**CITY OF BLOOMINGTON
PLAN COMMISSION**

November 7, 2016 @ 5:30 p.m.

**BLOOMINGTON PLAN COMMISSION
STAFF REPORT
LOCATION: 900-902 E. Cottage Grove Avenue**

**BLOOMINGTON PLAN COMMISSION
STAFF REPORT
LOCATION: 323 and 455 S. Westplex Ave.**

EXHIBIT A

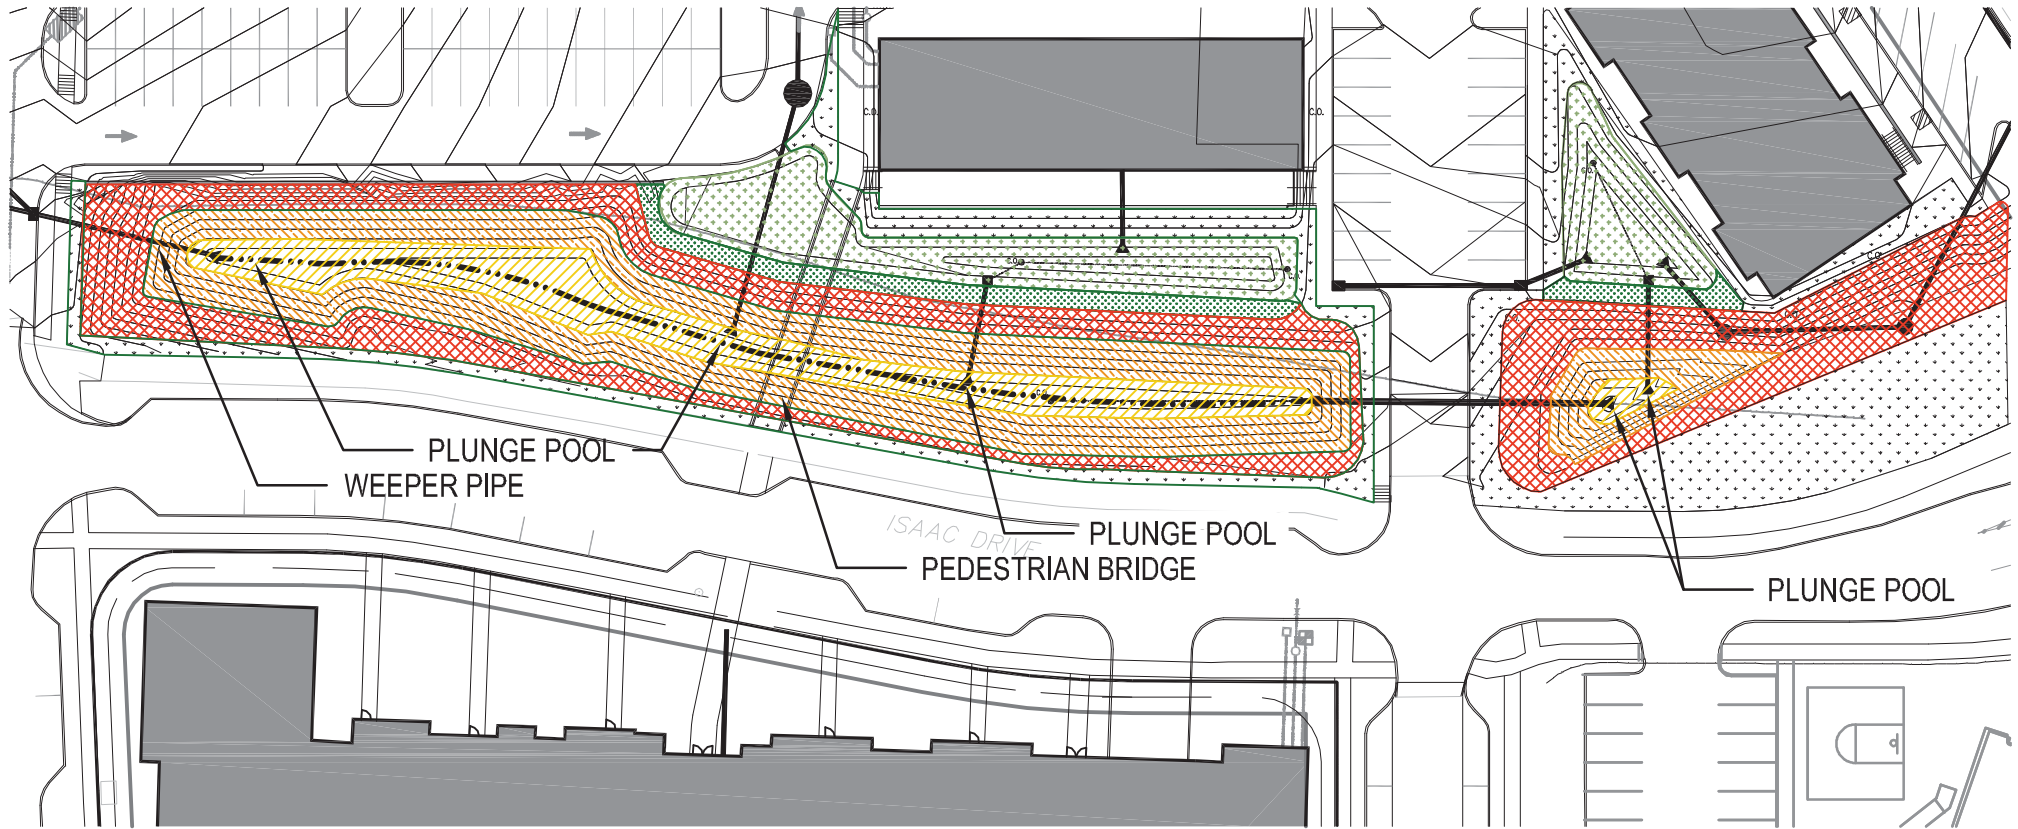
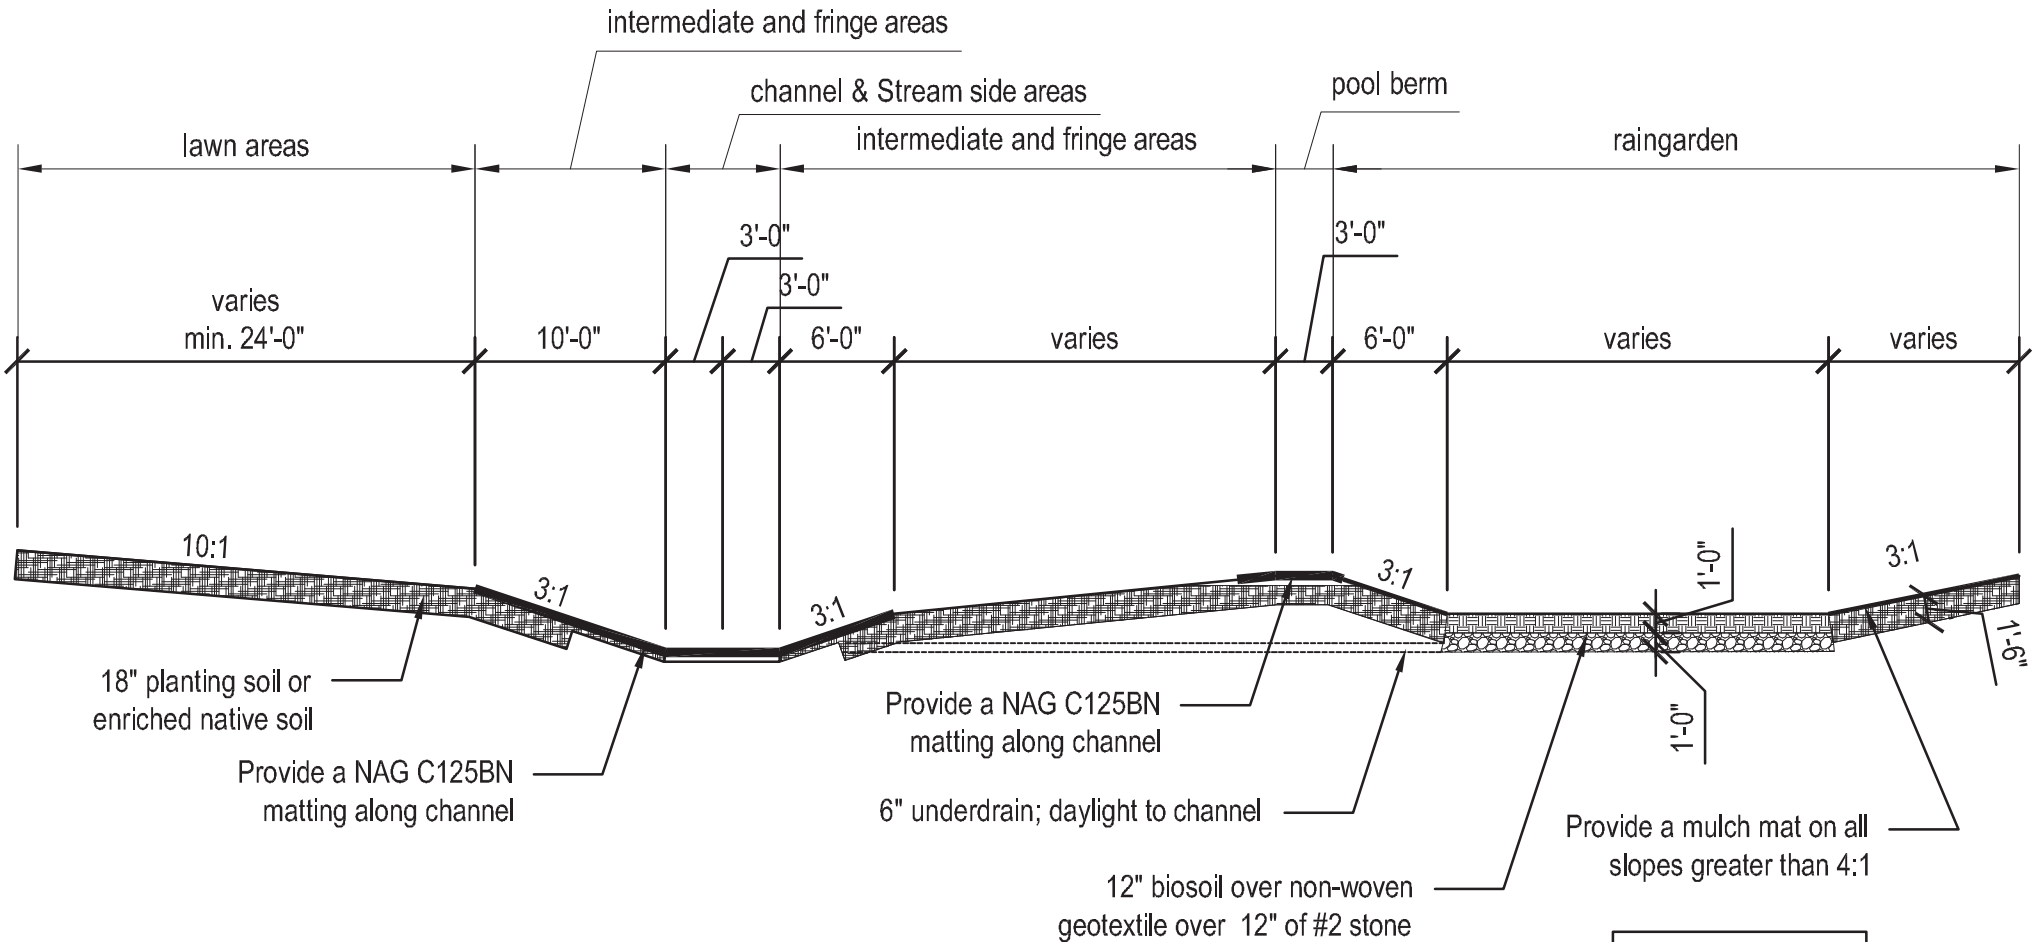
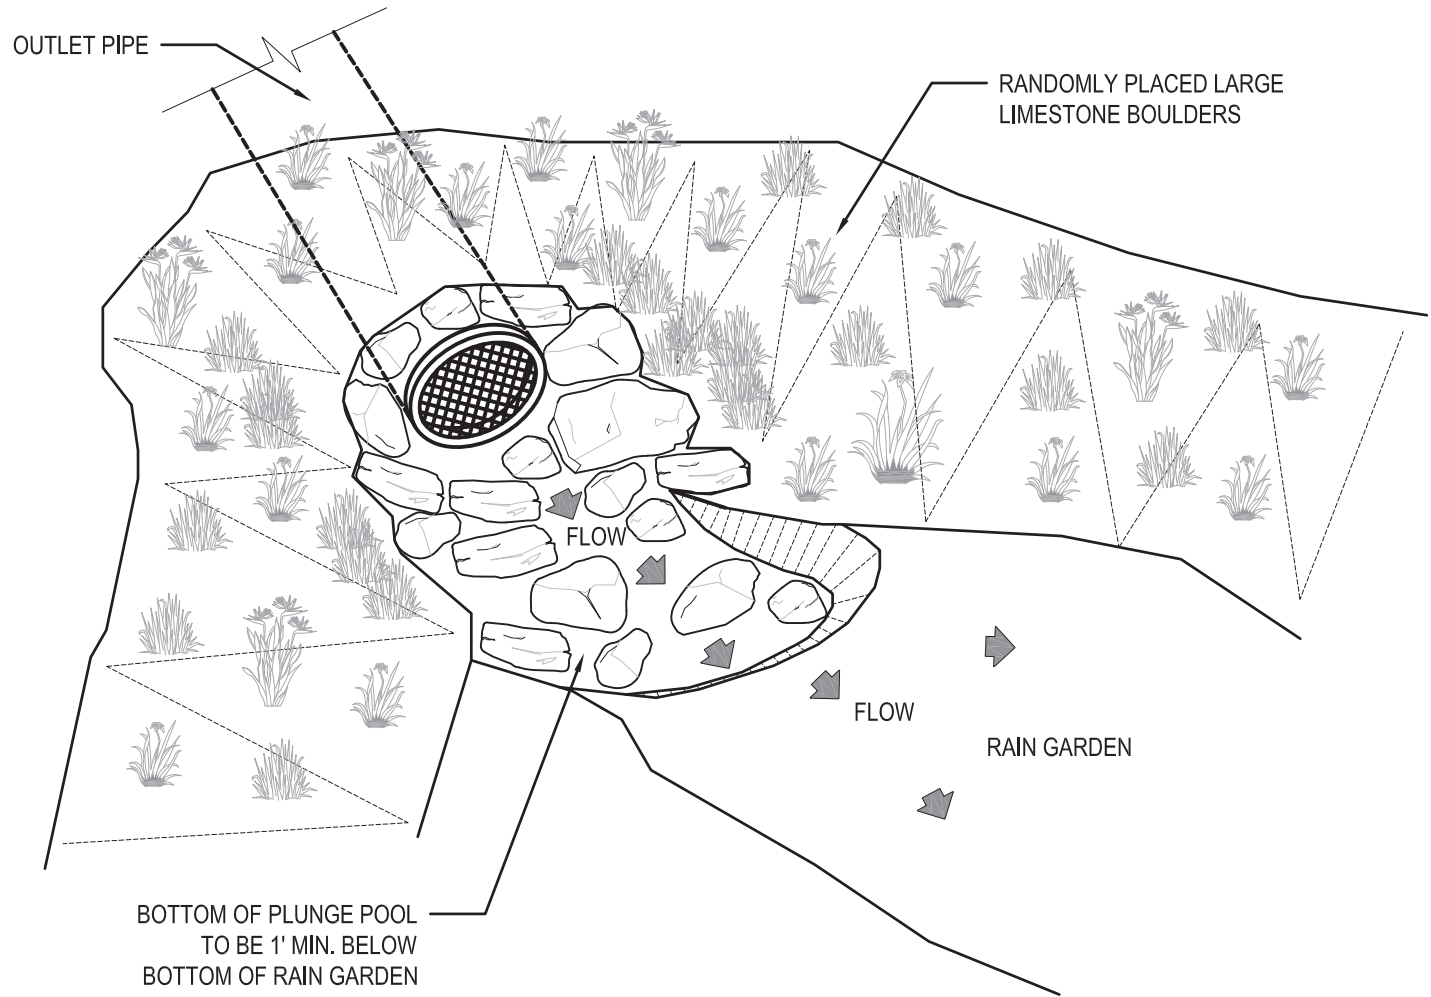
The current plan changes the nature of the restoration. The original plan included culverts under Westplex Ave. and the drive to the parking lot on A with an abutment and wing walls to be designed to feel like a bridge. The petitioner now proposes an at-grade crossing with land that slopes down to the bottom of the channel and longer pipes under the crossings. In addition, the middle section of the creek is designed more like a detention pond with an outlet structure in the downstream section. Please see the Environmental Commission report for more details.

The original PUD intent was to create a "showplace" of sorts for urban stream restoration. With this new proposal, the restored creek is no longer meandering, no longer embodies deeper pools and shallower riffles, and no longer embraces strategically placed limestone boulders and trees for erosion control or stream habitat. The riparian buffers have no trees or shrubs and much less herbaceous plant diversity than originally planned. The plan instead now shows a linear detention pond with native herbaceous plants installed on the sides.

The EC recommends that the list of issues and questions below be resolved prior to approving the revised plan.

- * Describe the removal of pavement and the amended soil to replace it.
- * Describe work to be done on the west side of Westplex Ave., and how wide the riparian buffer will be there.

- * What material will be on the stream floor?
- * Add the original allowable shrub and tree species in all three riparian buffer zones
- * All three riparian zones and the rain gardens need additional choices for acceptable forbs.

- 1.) The Petitioner should address the list of issues and questions aforementioned regarding the stream restoration plan.
- 2.) The Petitioner shall revise the landscape plan.
- 3.) The Petitioner should apply green building practices to create high performance, low-carbon footprint structures, and provide the infrastructure/space for recyclable-material collection.

Previous creek restoration plan

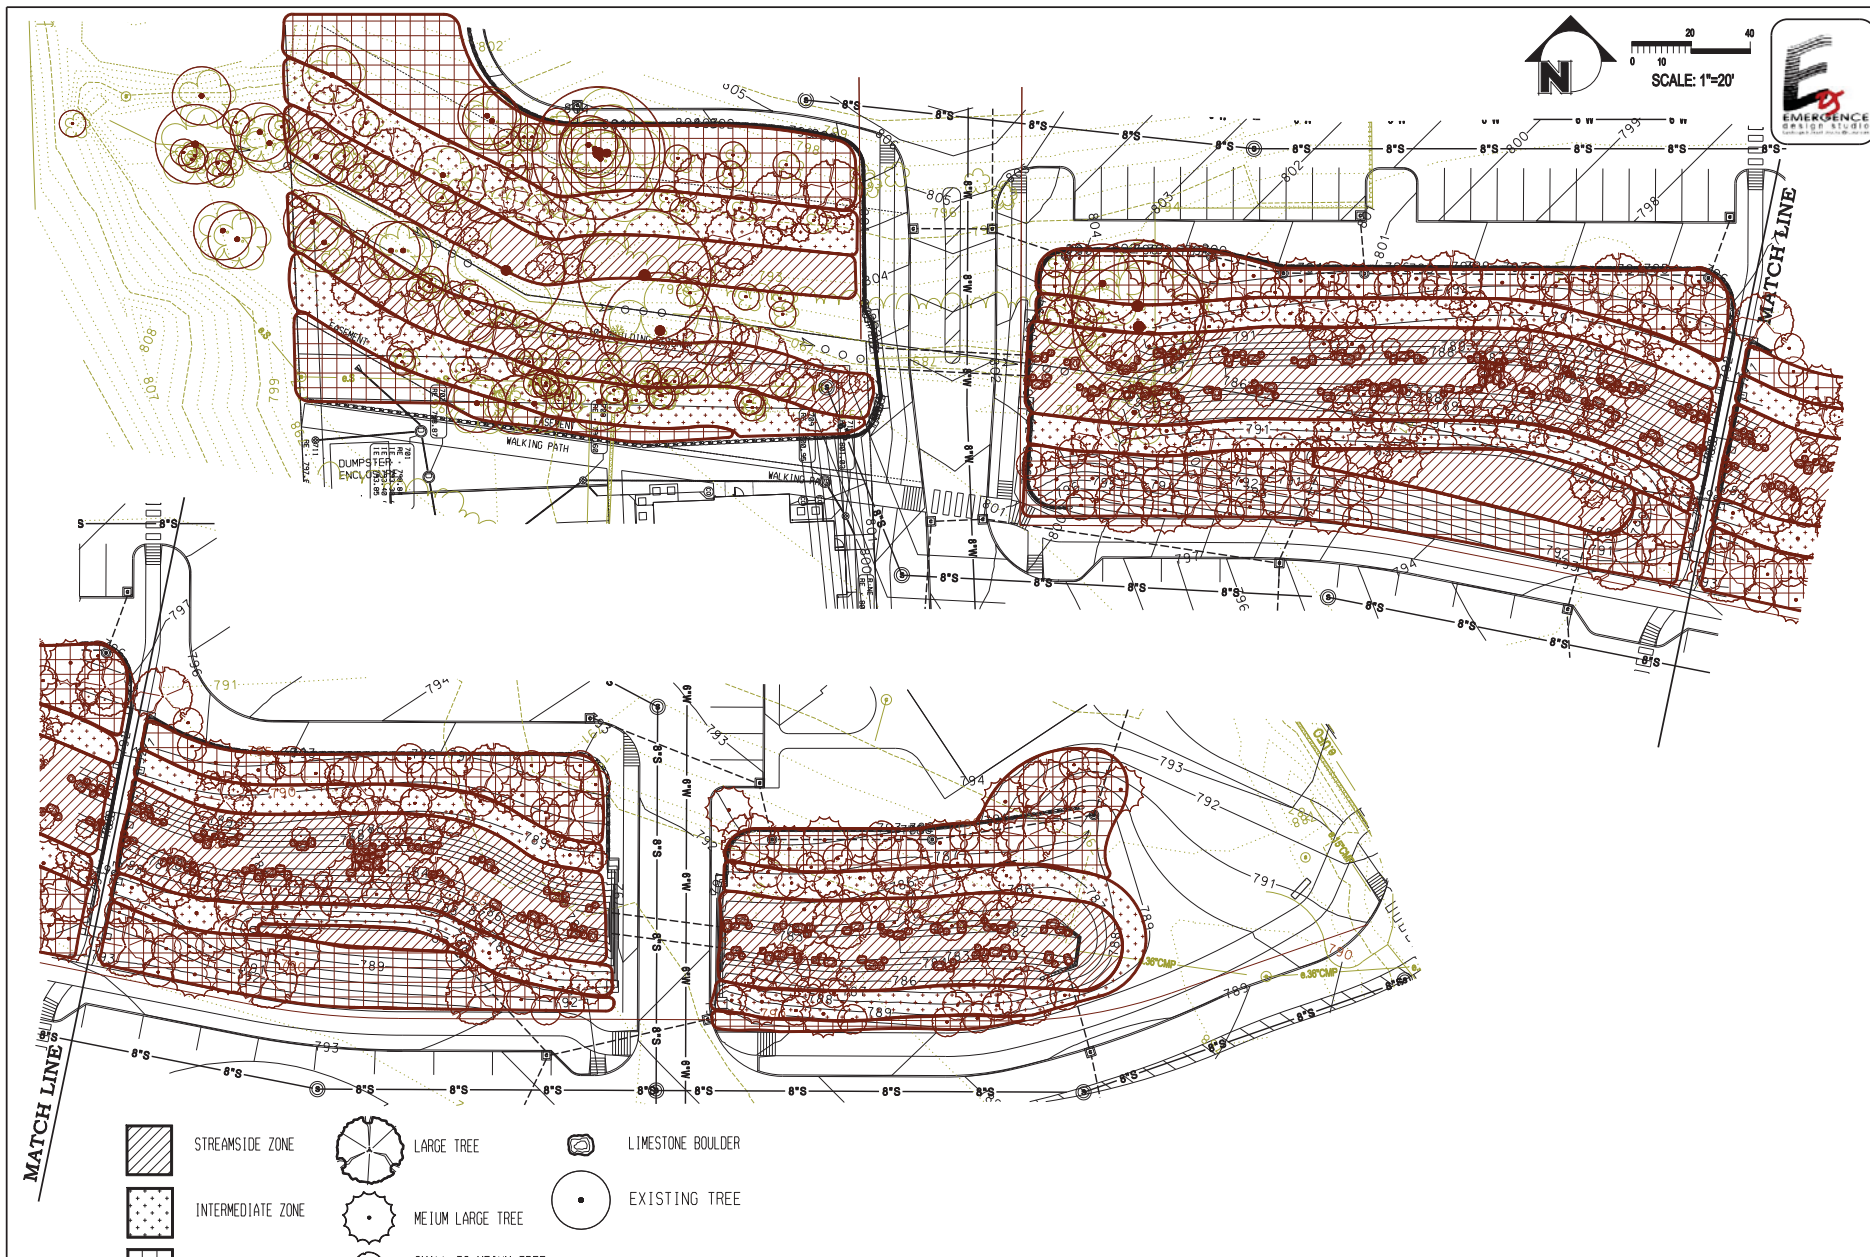
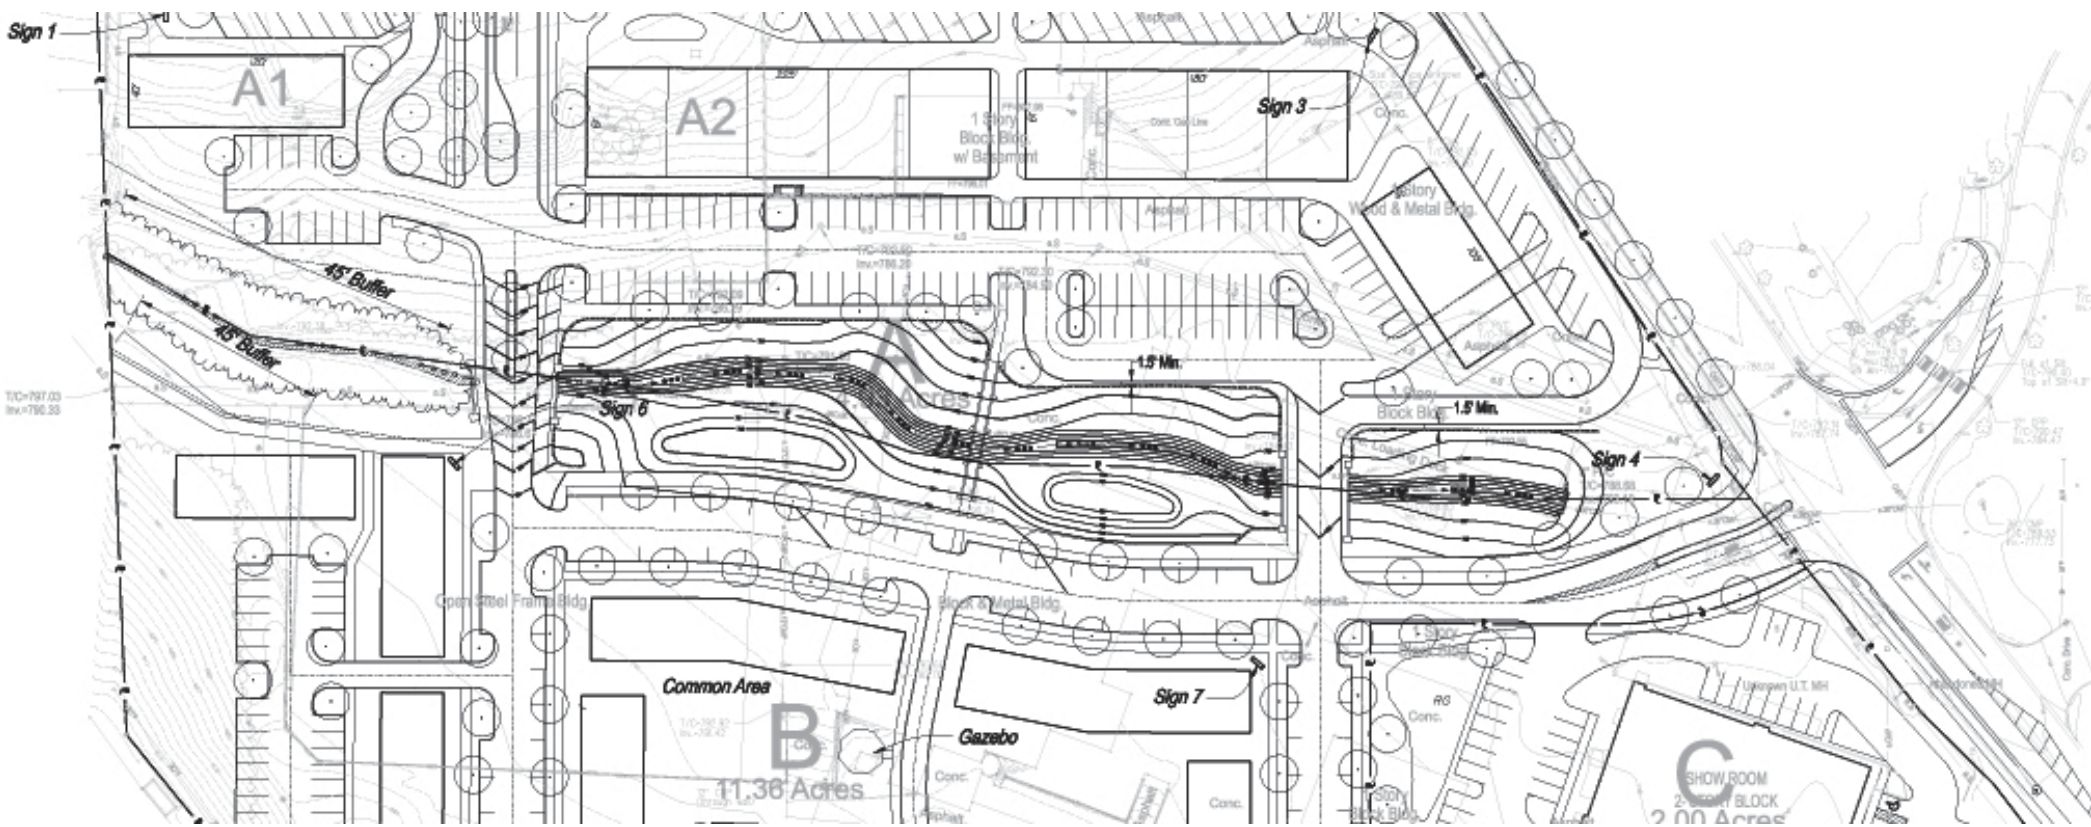
The proposed creek restoration differs significantly from the plan approved in the 2011 PUD Final Plan for the construction of Isaac Dr. That plan included the preservation of existing trees, systematic grading and soil and slope construction, removal of invasive species, planting of new trees, shrubs and grasses, and the creation of water quality basins for stormwater quality. In addition to the on-site riparian corridor work, the petitioner also reached an agreement with the upstream property owner to repair excessive erosion in the creek corridor immediately downstream of a box culvert outfall.

**Initial Parking Blvd Plan
Presented to Plan Commission**

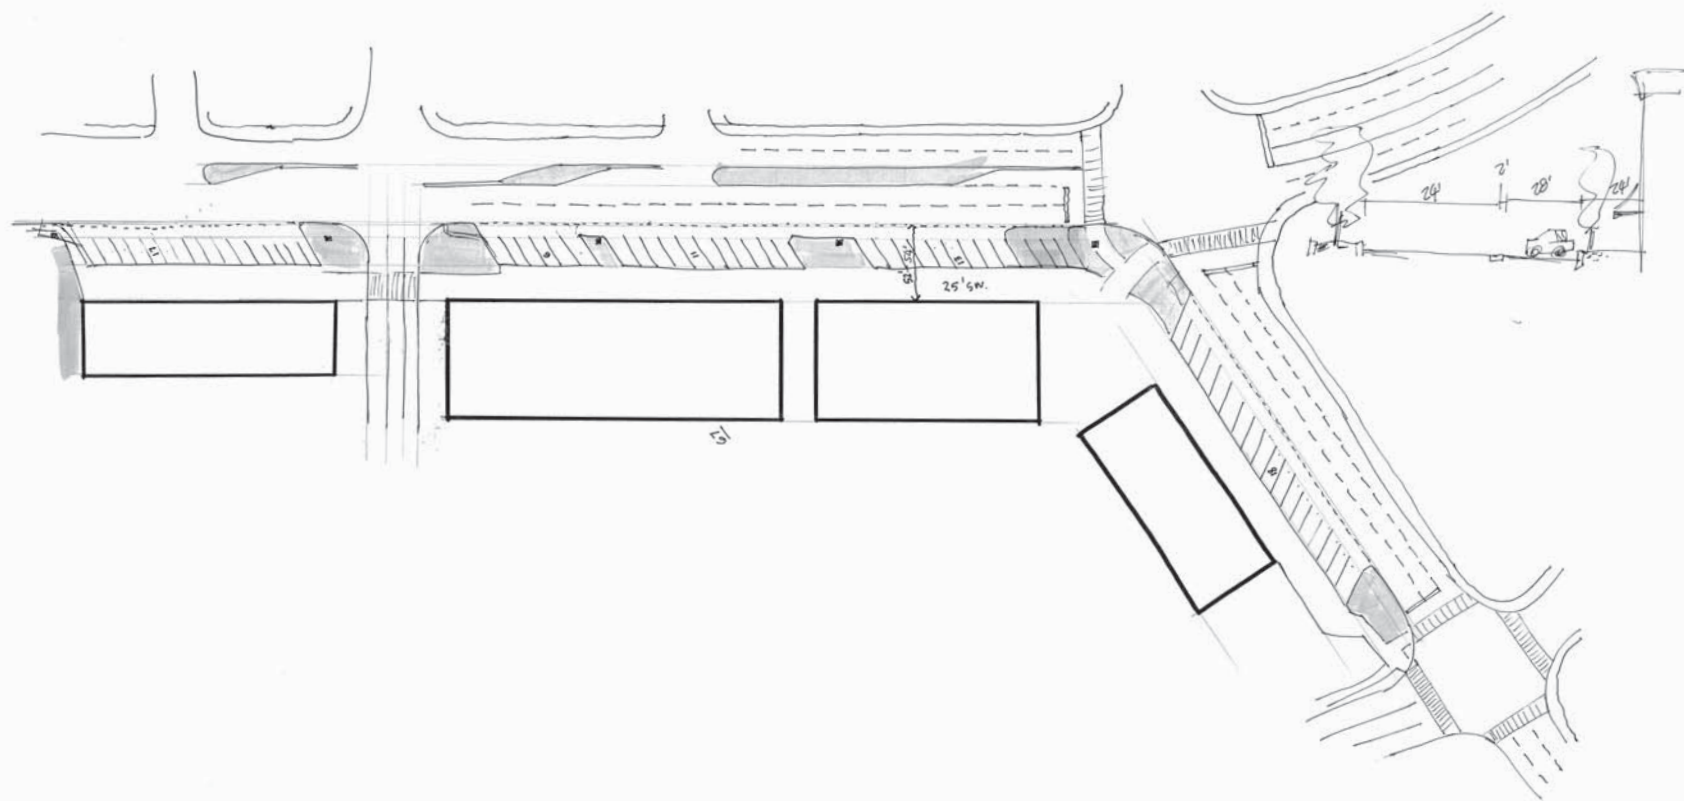
In 2010, the petitioner presented three different parking plans to the City Council. These three versions are included in the packet. The initial version was similar to the plan presented with this petition. The second version changed the orientation of the parking, pushing the parking spaces closer to the street and moving the access aisle closer to the buildings. This plan also provided for a "straight" connection between parts of Area A west of Westplex Ave. and the remainder to the east of Westplex Ave. with a single access point onto 3rd west of Westplex Ave. The third version was a more traditional street parking plan that included back-out on-street parking on Patterson and 3rd. The City Council did not specifically approve any of these plans, but instead provided for them to be "alternatives" that should be further evaluated by the Plan Commission at the time of the PUD Final Plan for Area A.

The petitioner's plan is most closely similar to the parking boulevard shown to the Plan Commission in 2010. With this, they have a single entry on 3rd street and an exit onto Patterson. The parking spaces are closer to the building and sidewalk. The parking boulevard does not extend across Westplex Ave as there are no current plans to develop Area A1 to the west of Westplex.
